SERVICE BULLETIN 132

SUBJECT: Glasair Super II-S Rudder Pedal Control Weldments

APPLICATION: Super II-S aircraft kits, S/N 2281 through 2306

FIGURE (1)

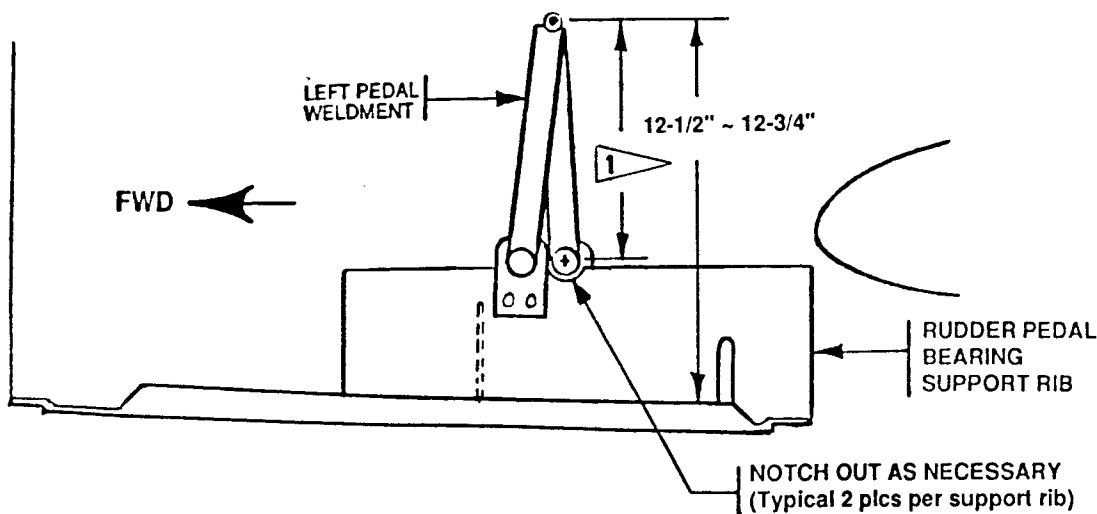
DESCRIPTION: A production run of Super II-S Rudder Pedal Control Weldments was made with pedal mount riser tubes that are 1/2" too tall. If mounted normally, this would cause problems with rudder pedal actuation of the brake master cylinders and positioning of the pedals in relationship to the bottom of the header fuel tank.

To determine if your kit is affected, measure the height of the center of the rudder pedal pivot point from the center of the pedal control weldment pivot tube. The correct dimension for this assembly is 6-7/8". The units in question measure 7-3/8". Refer to flag note 1, FIGURE (1). If your rudder pedal control weldments measure 7-3/8", this bulletin applies to your aircraft and you need to follow the modification instructions below.

RECOMMENDED ACTION: The simplest cure for this problem is to mount the rudder pedal weldments and their support bearings 1/2" lower than shown in the assembly manual (Fuselage Section, Step M-2 for Super II-S RG's and TD's, Step N-2 for the FT). This will position the rudder pedals correctly without noticeably altering rudder actuation. Measurement of our prototype Super II-S RG and other Super II-S aircraft under construction locally indicates that the center of the rudder pedal pivot bolt should be about 12-1/2" to 12-3/4" above the inner skin of the forward belly panel. Refer to FIGURE (1).

To accomplish this, follow the instruction manual normally until you are ready to actually mount the rudder pedal control assemblies and their bearings onto the bearing support ribs. After the desired fore and aft location has been determined, mark the location of the assemblies and notch out the support ribs in this area enough to lower the weldment cross tubes 1/2". Remove only enough support rib material to accomplish this task.

If your rudder pedal weldment assemblies are already mounted per the manual and they need to be lowered, it is a simple matter to remove the assemblies, notch out the support ribs and re-mount the support bearings 1/2" lower.

NOTE: DO NOT remove any material from the support ribs in the areas where the lower ends of the master cylinders mount (forward of the pedal assemblies); the master cylinders need to stay in their normal positions to maintain proper geometry with the rudder pedals.

Check that the rudder pedal pivot bolt (or its mounting pivot tube) is positioned as called out above and then proceed with the installation as normal.
